**Re: Valle Vista at the Trails Unit 3
Grading and Drainage Plan, Engineer's Stamp Date 6-23-14 (C09D009)
Engineer's Certification dated 2-28-15, Supplemental Information 3-9-15**

**VALLE VISTA UNITS 1, 2 & 3
GRADING AND DRAINAGE PLAN**

Re: Grading and Drainage Certification, Valle Vista Units 2 and 3
DRB Case No. 1004606, (C09/D009)

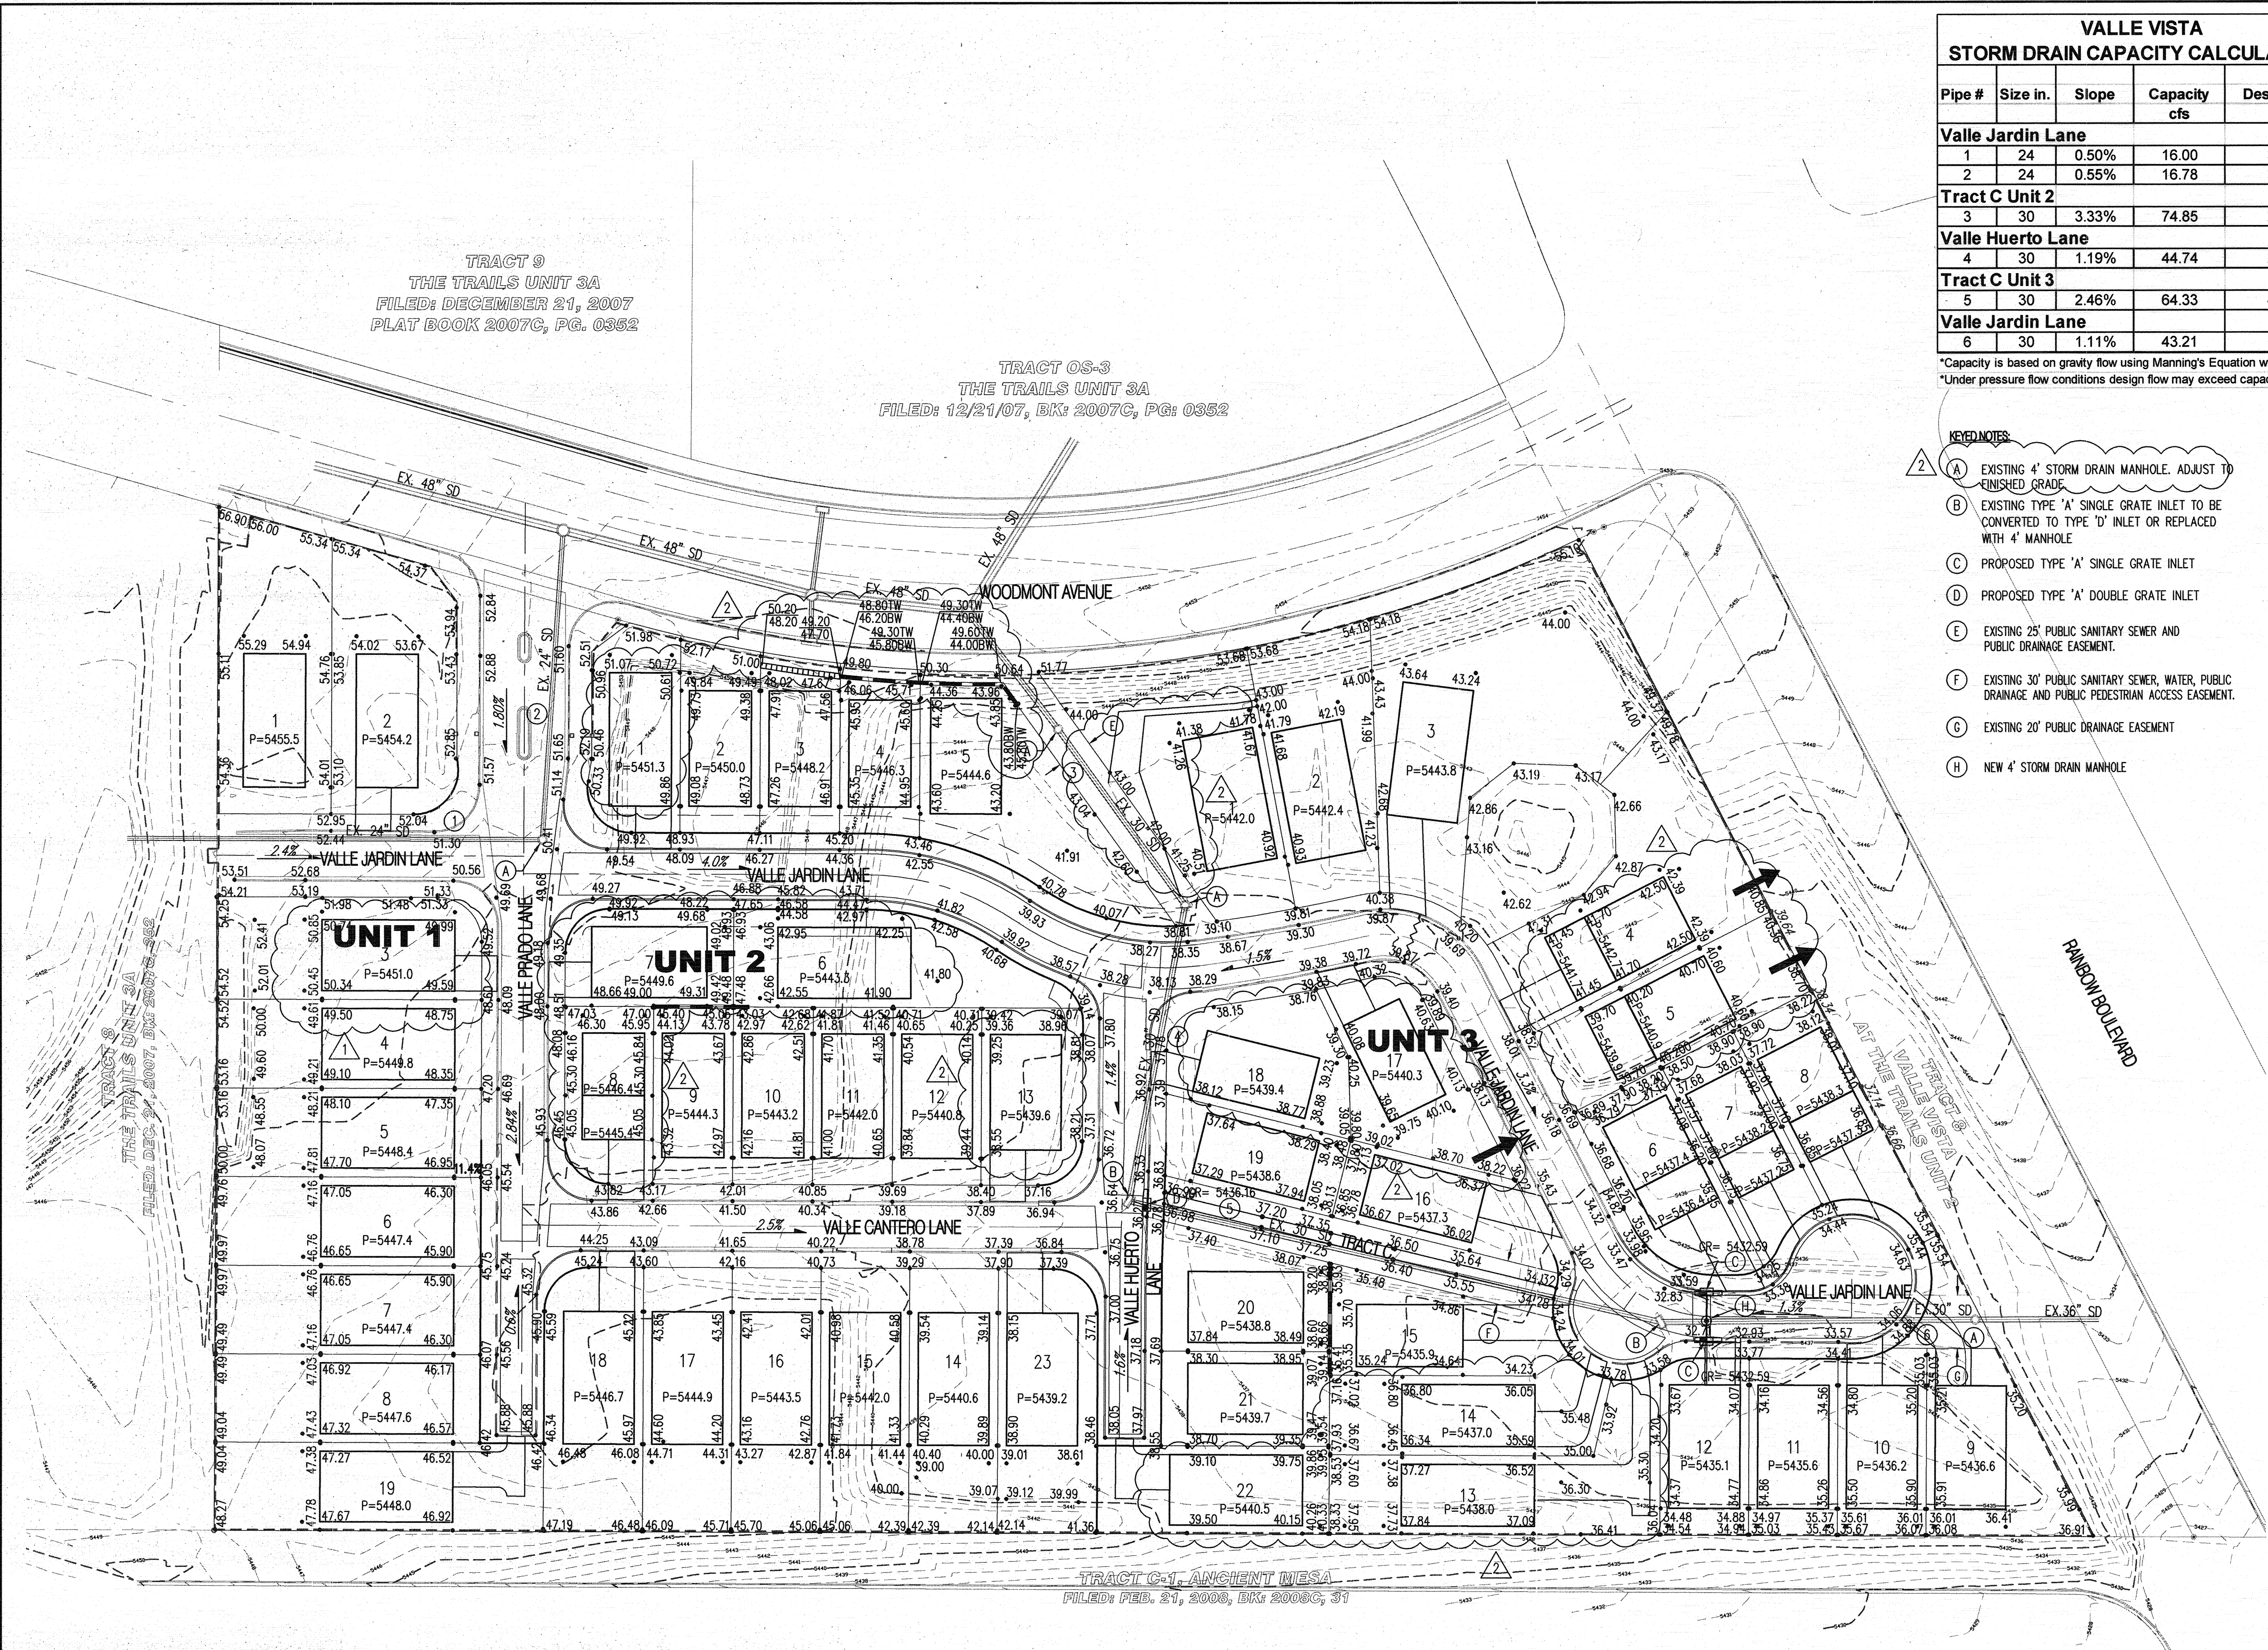
Based upon the information provided in your submittal received 3-2-15, and supplemental information received 3-9-15, the above referenced plan is accepted for Release of Financial Guarantee for grading and drainage for Unit 3 only.

Please note that for Unit 2, a new submittal is required which includes lots 6-9 as part of the Certification.

CITY OF ALBUQUERQUE PUBLIC WORKS DEPARTMENT			
VALLE VISTA UNITS 1, 2 & 3 GRADING AND DRAINAGE PLAN			
Design Review Committee	City Engineer Approval	Last Design Update	Mo./Day/Yr.
City Project No.	Zone Map No.	Sheet	Of
XXXXXX	C-09-Z	1	2

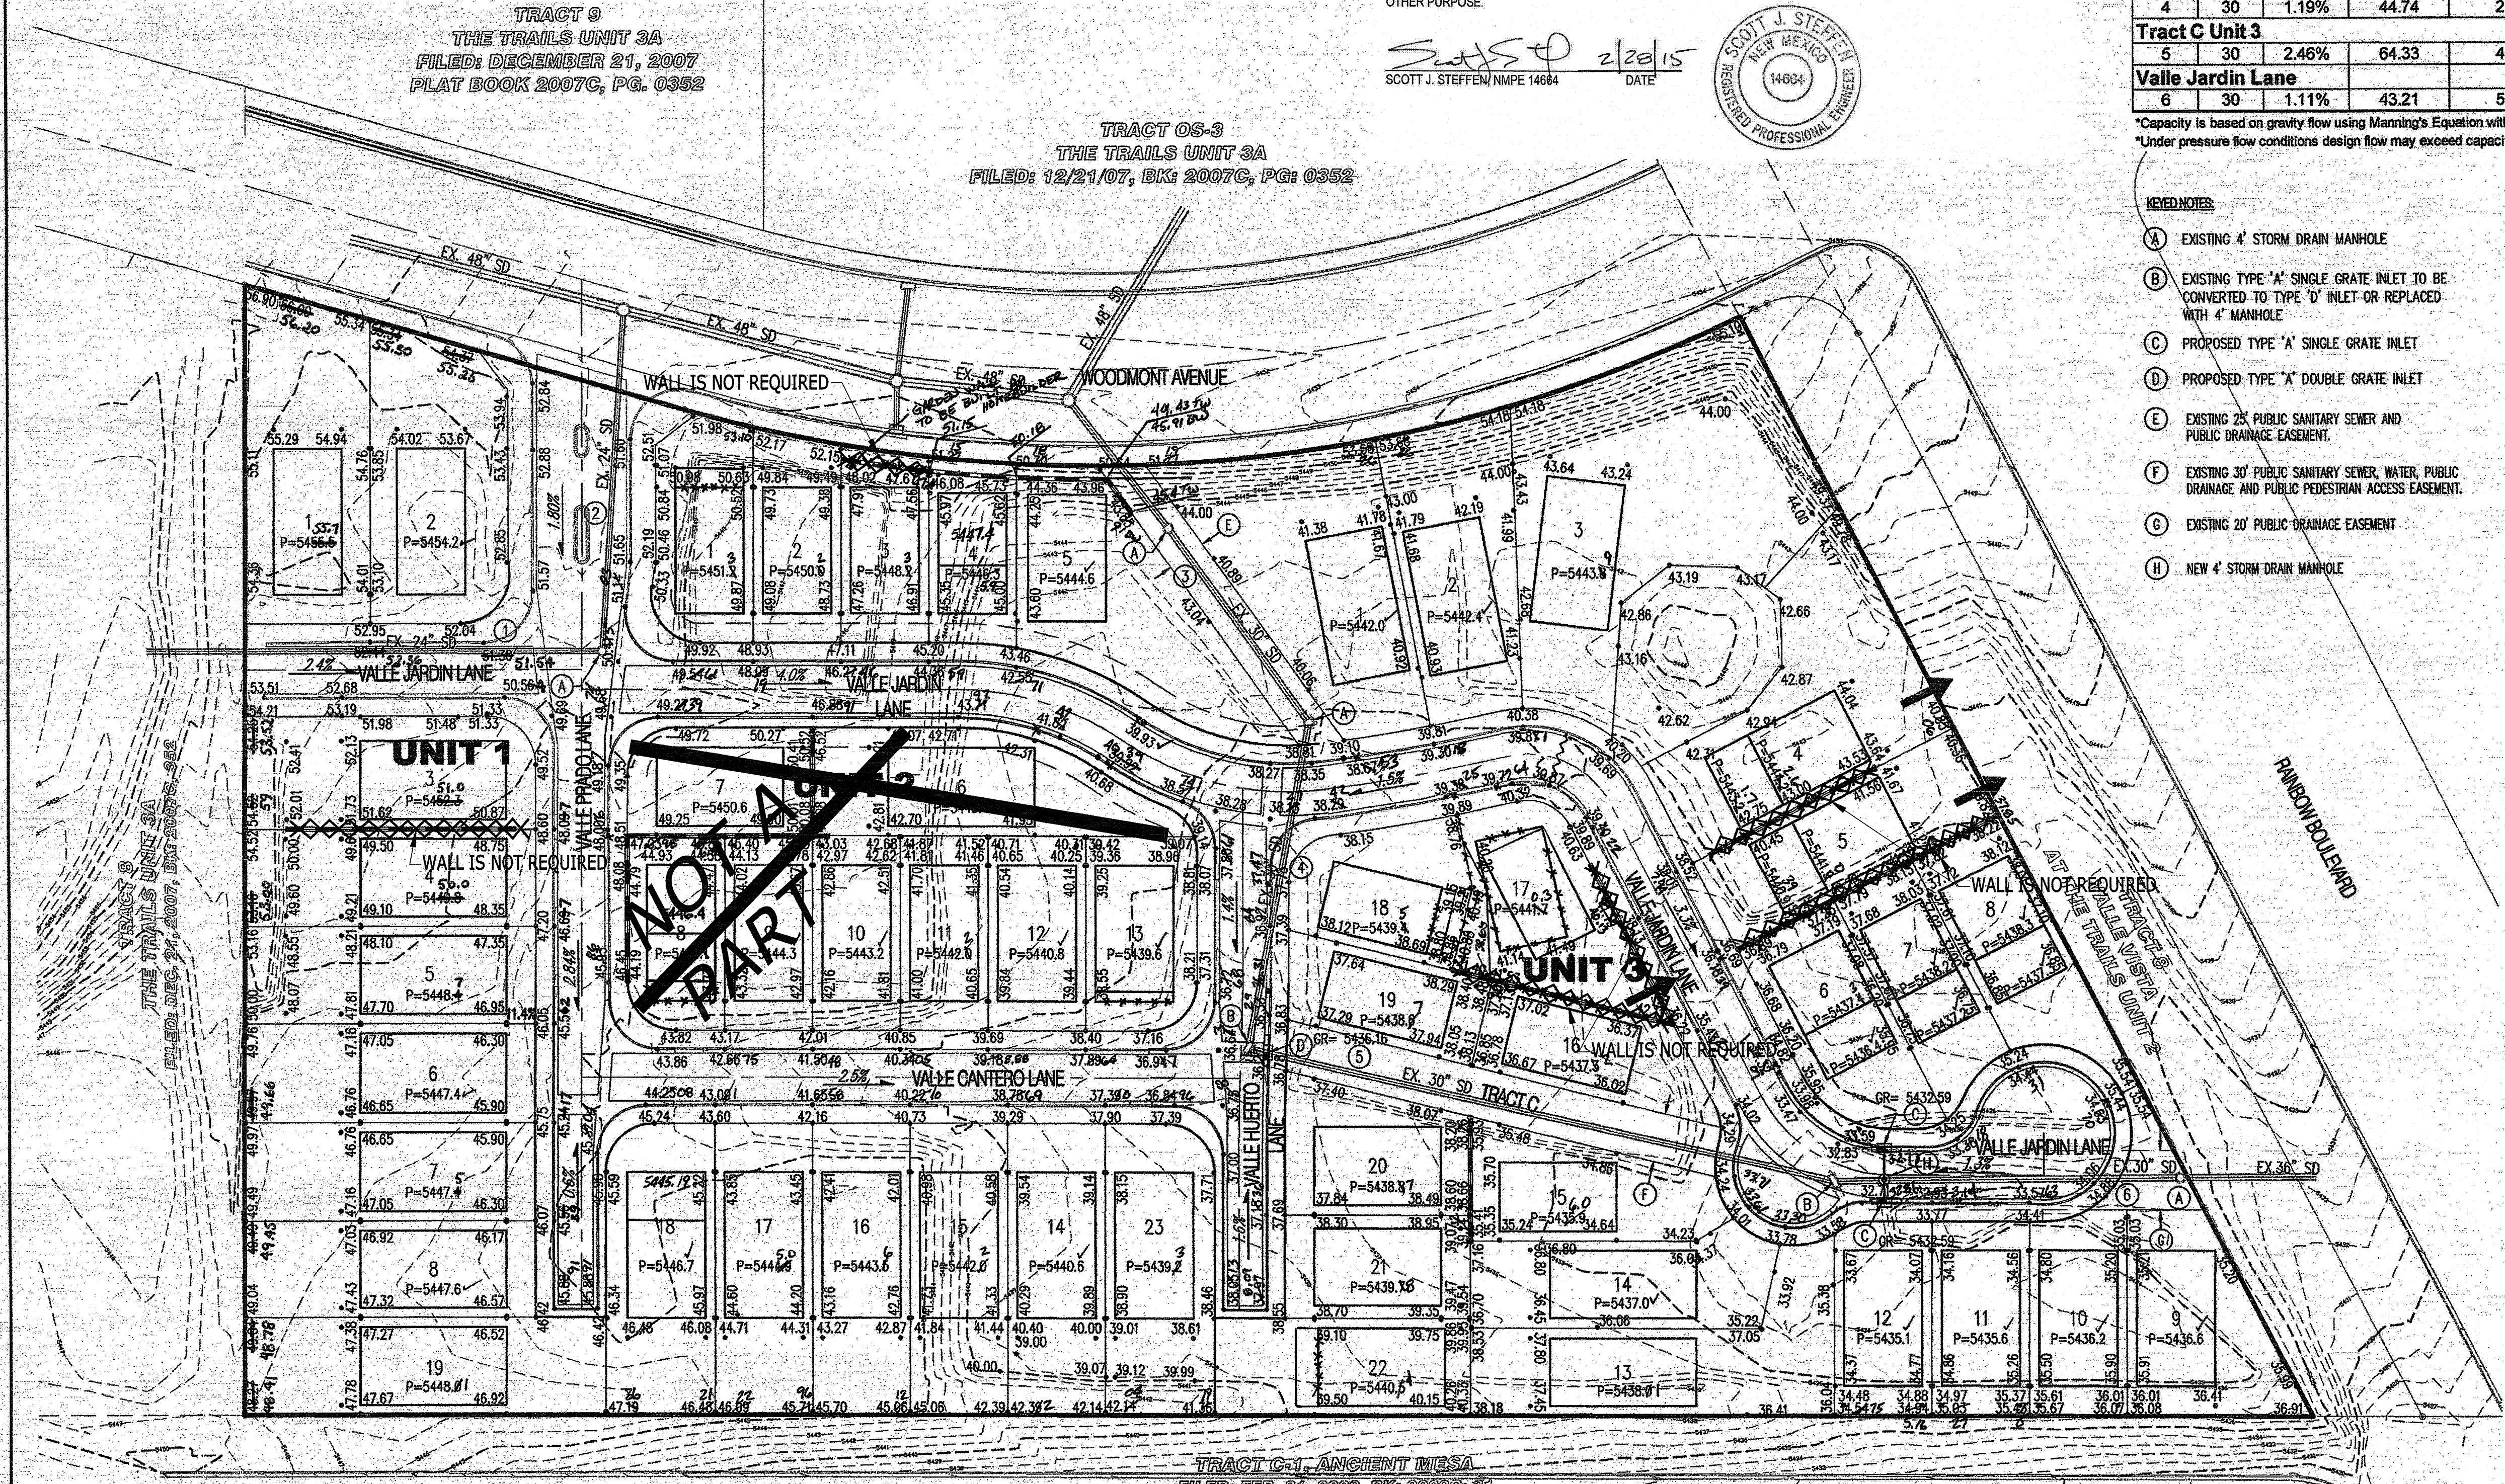
- Lot 1 – Pad depth increased from 65' to 75'.
- Lot 3 – Lower rear yard retaining wall is no longer required as the existing wall along the rear property line is able to accept a greater split than originally thought. The retaining wall is replaced by a garden wall to be built by the homebuilder.
- Lot 4 – Pad was built as a split pad to reduce the height of the lower rear yard retaining wall and reduce the driveway slope.
- Lot 13 – Pad was reduced from 70' to 65' to remove the pad from the 10' Public Utility Easement.
- Lot 18 – Pad was built as a split pad to reduce the driveway slope as the driveway needs to be on the low side of the lot. The upper pad matches the original pad elevation.

- Lot 4 – Pad elevation decreased by 1.5' as it was determined that the depth to basalt rock was deeper than originally thought. This lower elevation also reduces the driveway slope.
- Lot 5 – Pad elevation decreased by 1.0' as it was determined that the depth to basalt rock was deeper than originally thought. This lower elevation also reduces the driveway slope.
- The lowering of the Lot 4 and 5 pad elevations reduced the Lot 4/5 side yard split to less than 2.0', therefore eliminating the side yard retaining wall.

- The lowering of the Lot 5 pad elevation reduced the Lot 5 side yard and Lots 6-8 rear yard splits to less than 2.0', therefore eliminating the side/rear yard retaining wall.
- Lot 17 – Reposition the pad to increase the pad depth from 57' to 60' to meet the homebuilder minimum pad depth requirement. The entire back yard now drains to the low point wall drain as shown on the original grading plan. This allowed the pad elevation to be lowered by 1.4', reducing the side yard split next to Valle Jardin Lane and the Lot 16 side yard and Lot 17 rear yard split to less than 2.0', eliminating the retaining walls in these locations.
- Lot 18 - Pad depth increased from 57' to 65'. Reconfiguration of the Lot 17/18 common lot line, such that Lots 16-19 now share a common rear corner, eliminated the need for the Lot 19 side yard retaining wall.
- Lot 22 – Pad depth increased from 65' to 75'.
